SERVICE NO. 1299 BULLETIN

Date: January 6, 2017

PERIODIC REPLACEMENT OF MAIN LANDING GEAR DRAG LINK BOLT

PA-23-150 Apache
PA-23-160 Apache
PA-23-235 Apache
PA-23-250 Aztec

Figure 1
Drag Link Bolt Assembly Location

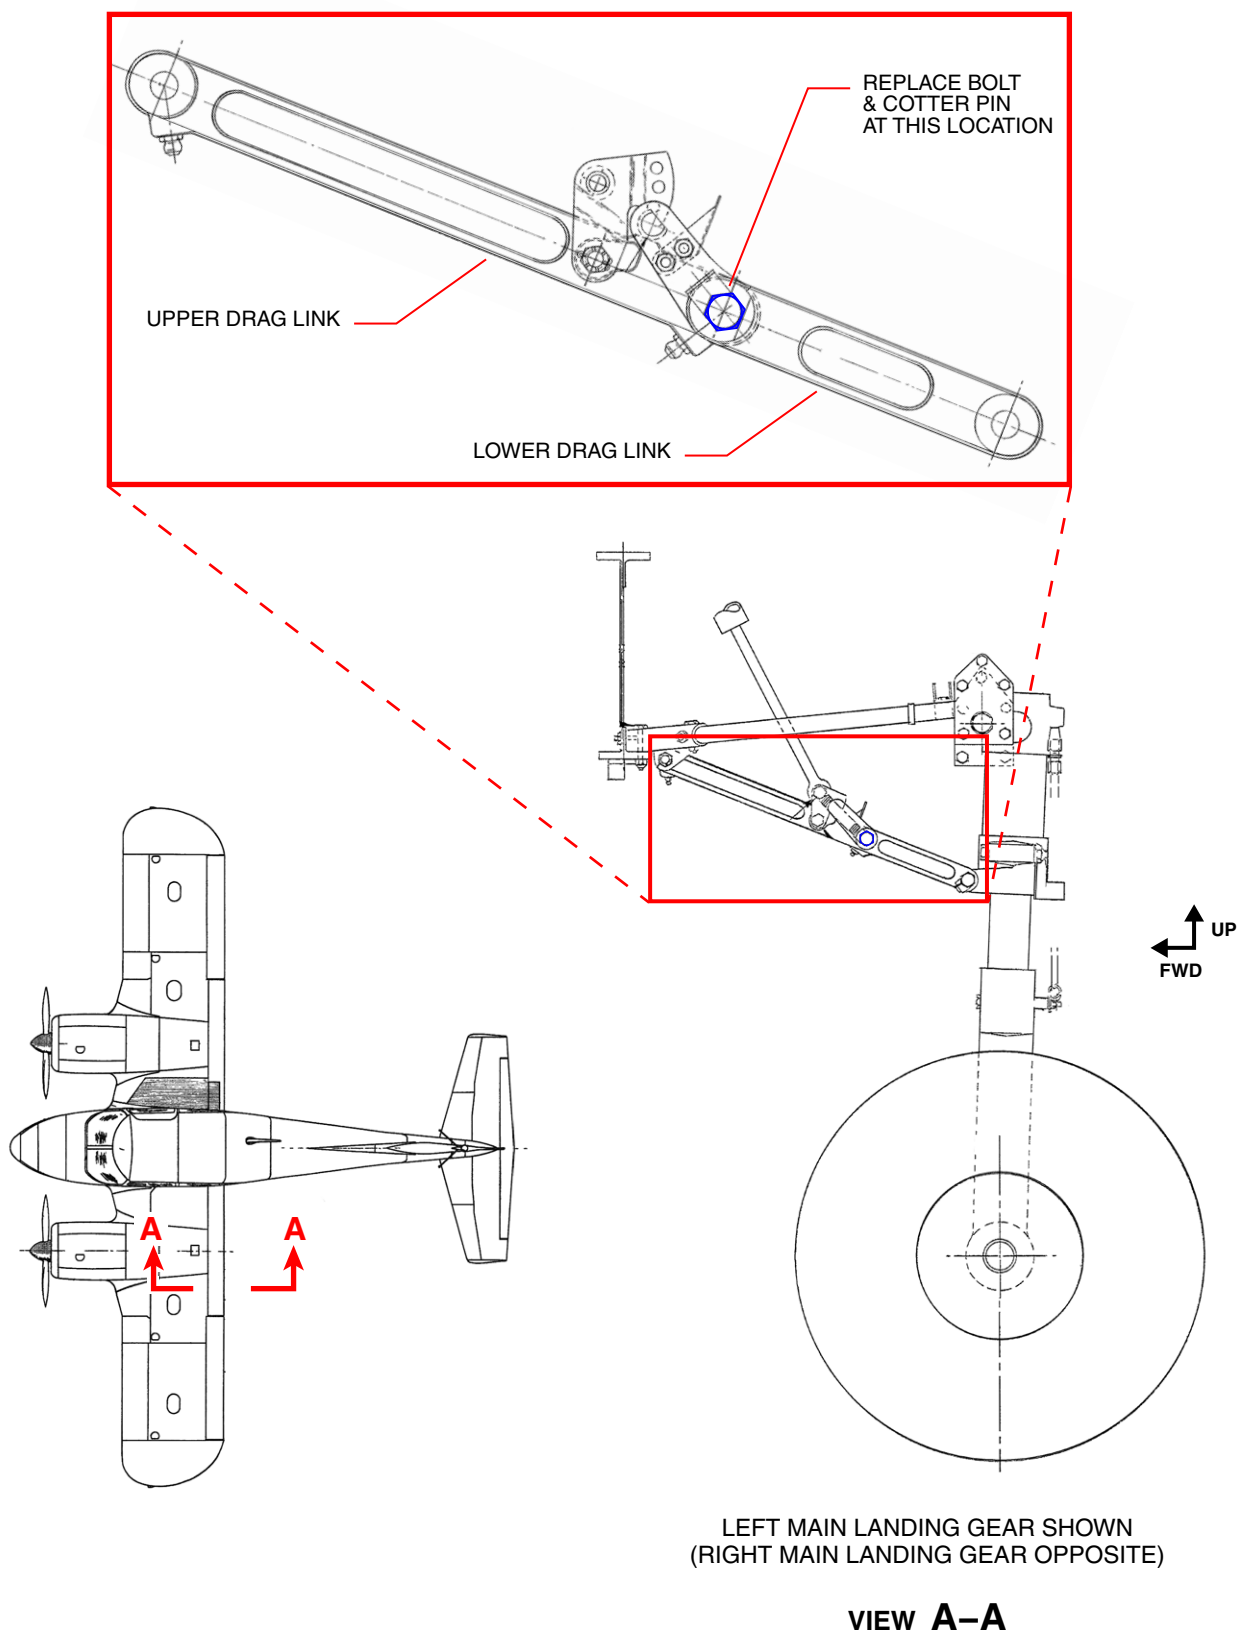
Under certain conditions, the bolt that fastens the upper and lower main gear (MG) drag links can develop wear in a manner that may not be detectable during routine maintenance and inspection. Specifically, score marks have been discovered around the circumference of the bolt shank, midway along the length of the bolt.

By design, the main landing gear drag link bolt is free to rotate inside a set of bushings to allow relative movement between the upper and lower drag links during landing gear strut extension and retraction. Over extensive operating hours, this rotation can generate the score marks described, causing stress concentrations to develop in the bolt, which, if left uncorrected, could result in bolt fatigue failure and subsequent main gear collapse.

1. Jack the aircraft per Section II of the appropriate service manual.
2. Disassemble the upper drag link from the lower drag link by removing the bolt, and associated hardware, which functions as a hinge pin for the two parts. See Figure 1.

3. Inspect the washers and castellated nuts for corrosion, damage and excessive wear, and replace on condition. Retain all serviceable hardware for later reassembly. Discard the used bolt and cotter pin.

4. Reassemble the upper and lower drag links, using new bolts and new cotter pins as listed in the Material Required section of this service bulletin. Existing nuts and washers may be reused, if they are in serviceable condition. If replacement nuts and/or bolts are required, order and install new parts as listed in the Material Required section of this service bulletin.
